October 31, 2017

**RE: Industrial Water Engineering
Conceptual Grading and Drainage Plan
Engineer's Stamp Date 10/26/17
Hydrology File: C16D006LL**

Based on the information provided in the submittal received on 10/26/17 the above-referenced submittal cannot be approved for Building Permit until the following are addressed.

SHEET NO.
CG-101

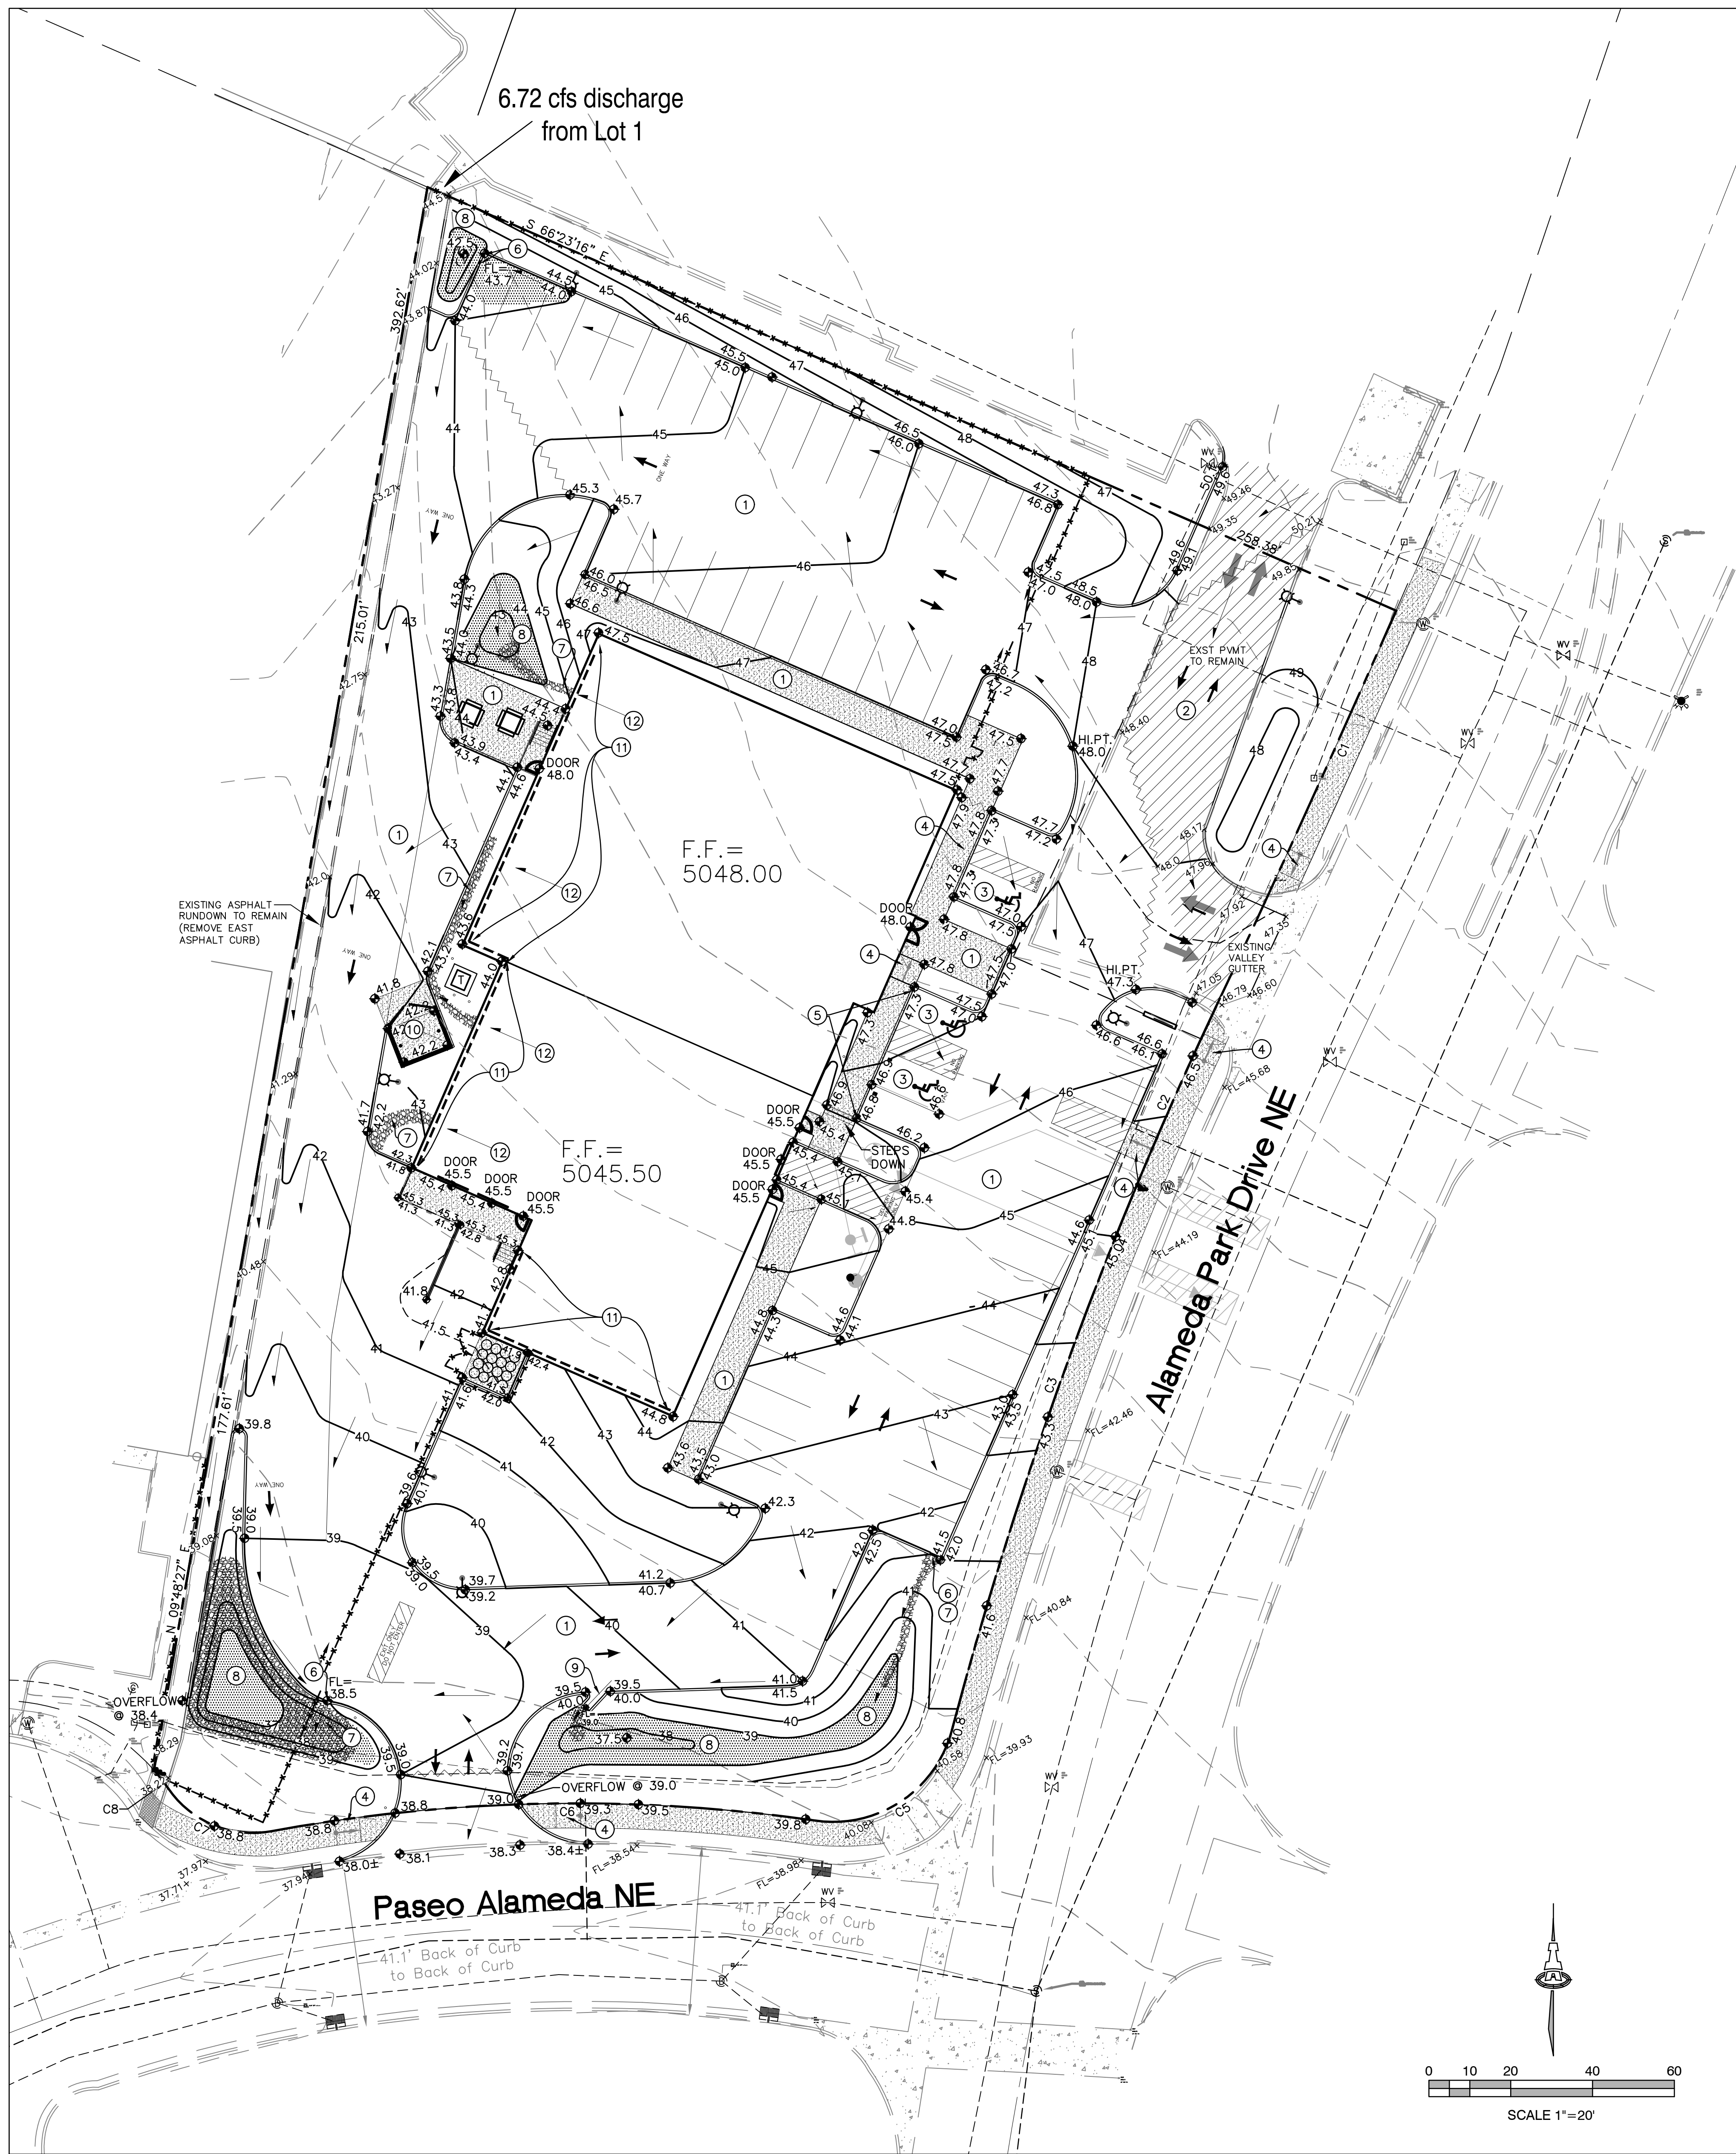
1. Correct text size on callouts to be 0.10" or larger; this applies mostly to the survey info for the water valves, drop inlets, and storm drain.
2. Call-out top of pond, bottom of pond, and volume on sheet CG-101.

CG-501

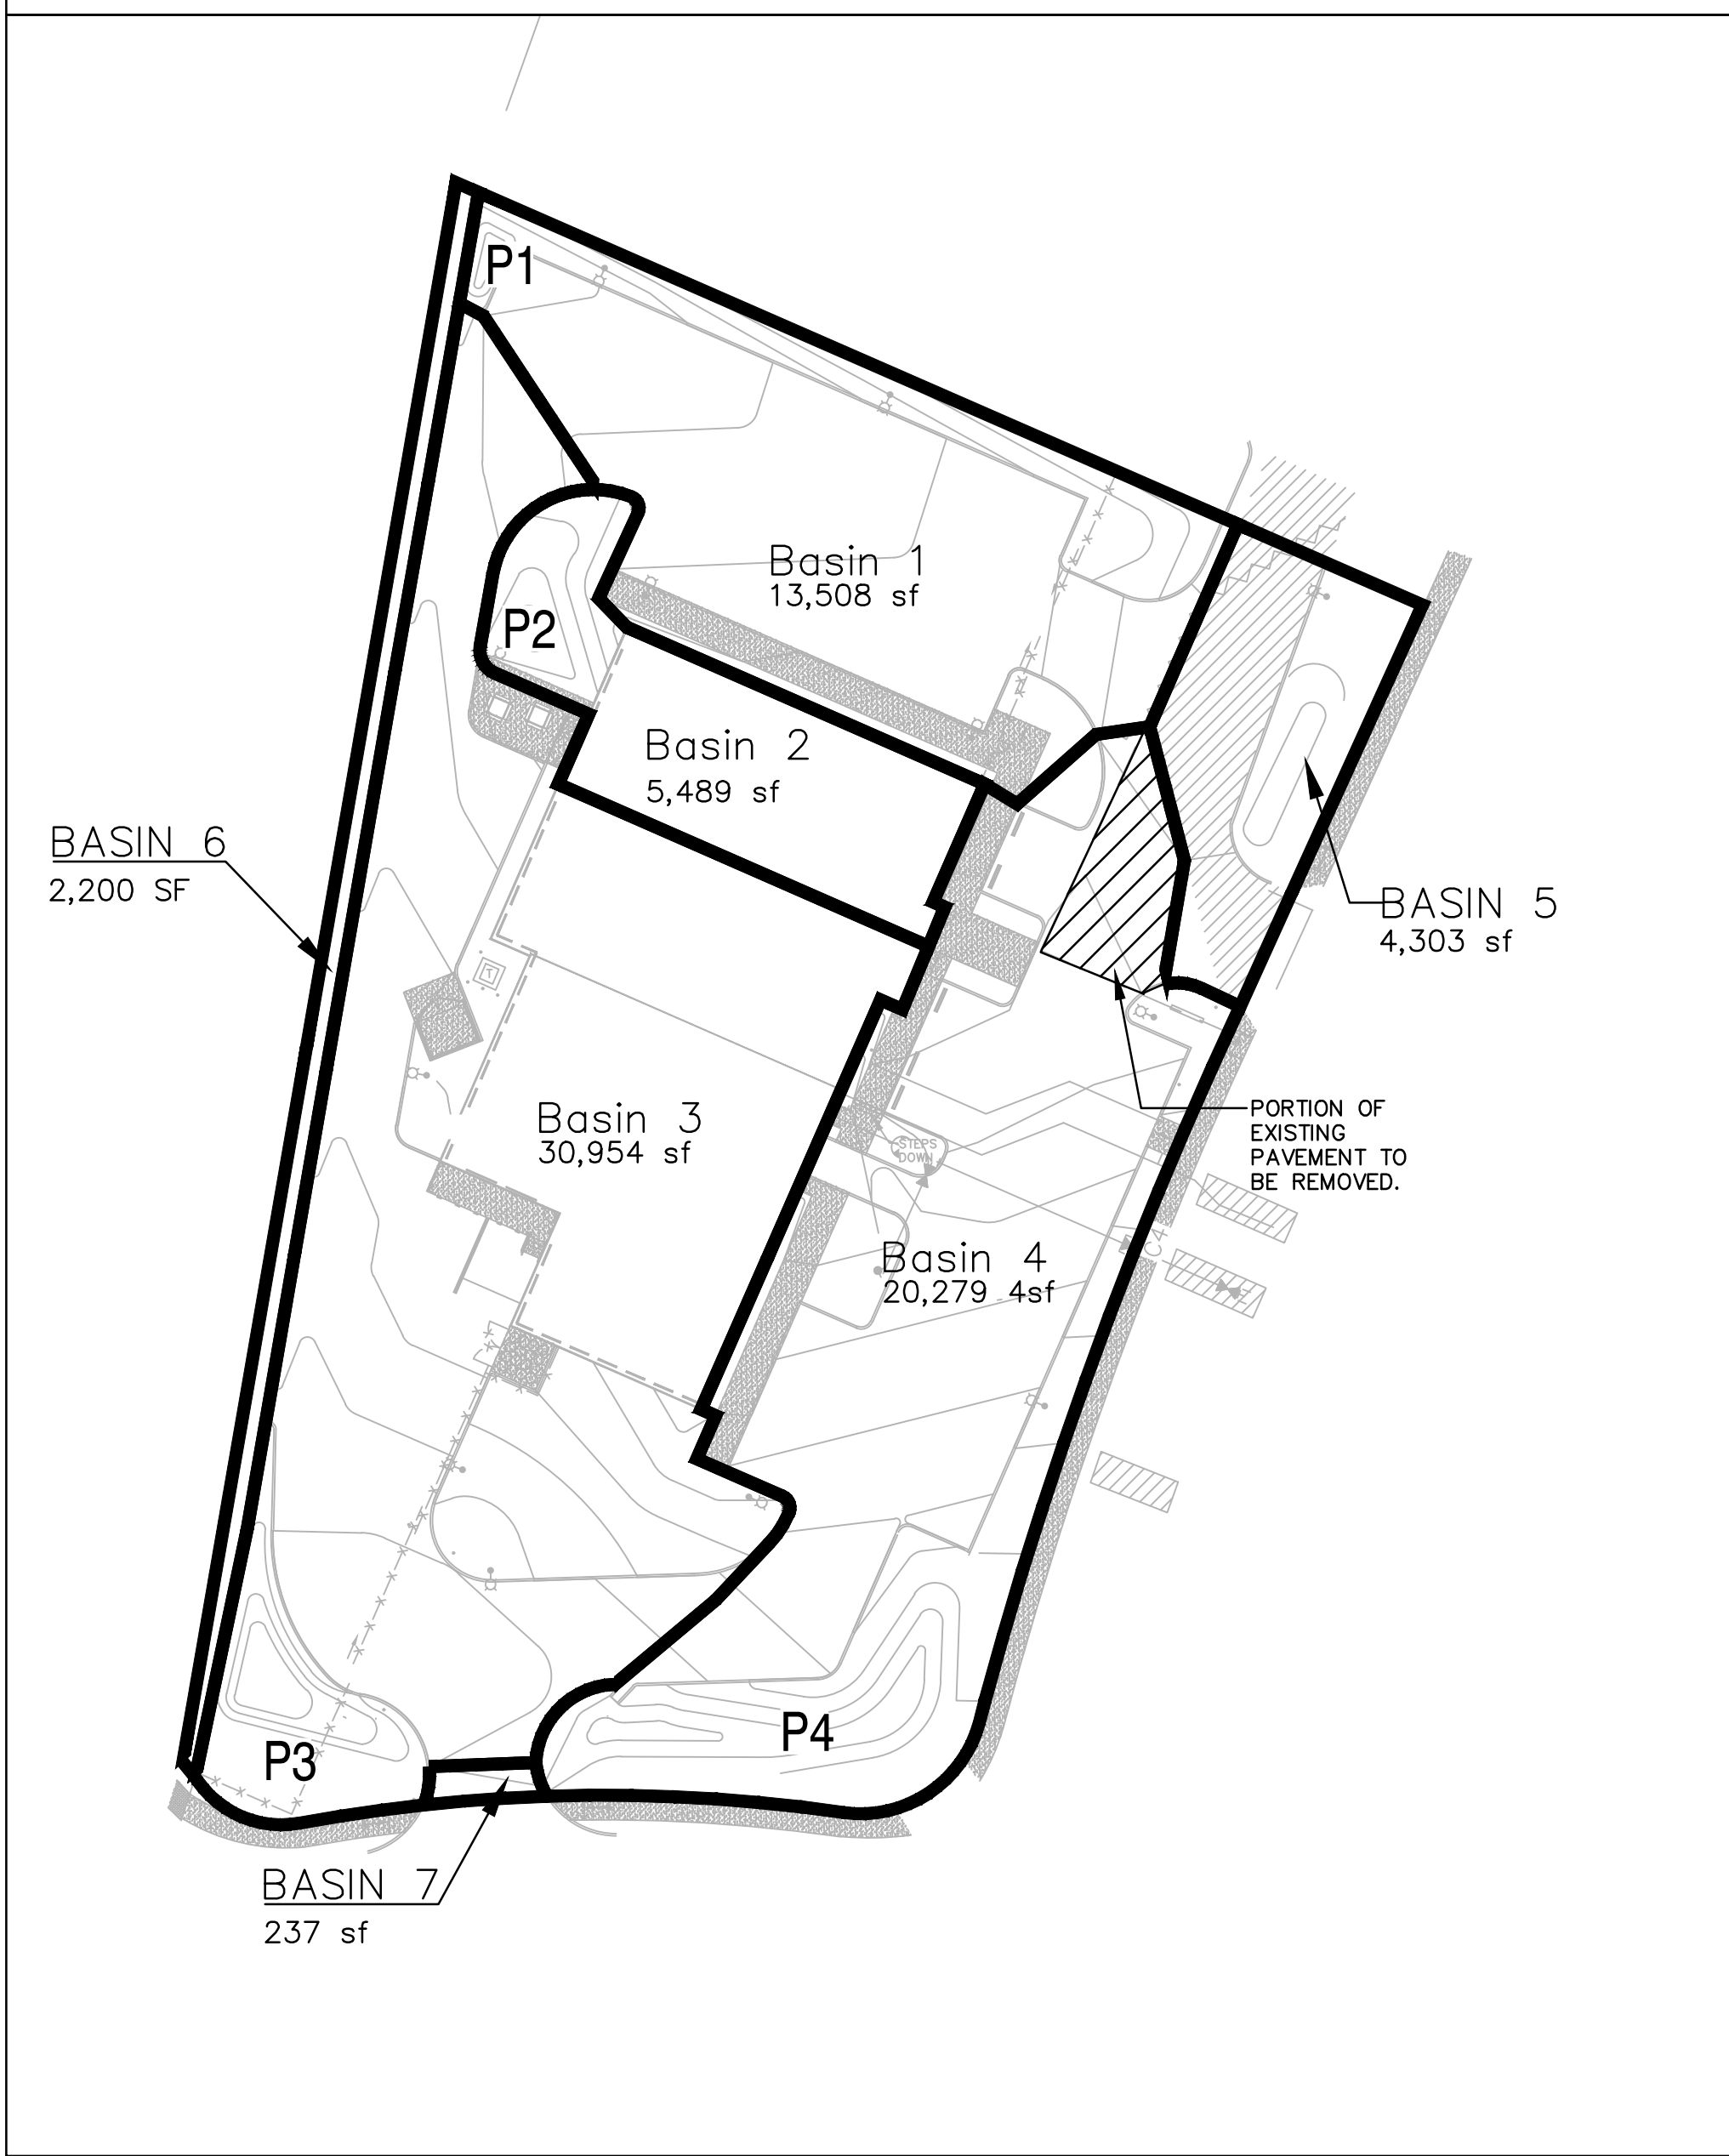
5. Provide hydraulic capacity calculations for the new sidewalk culvert and for the drainage channel downstream of the overflow from Pond P3.
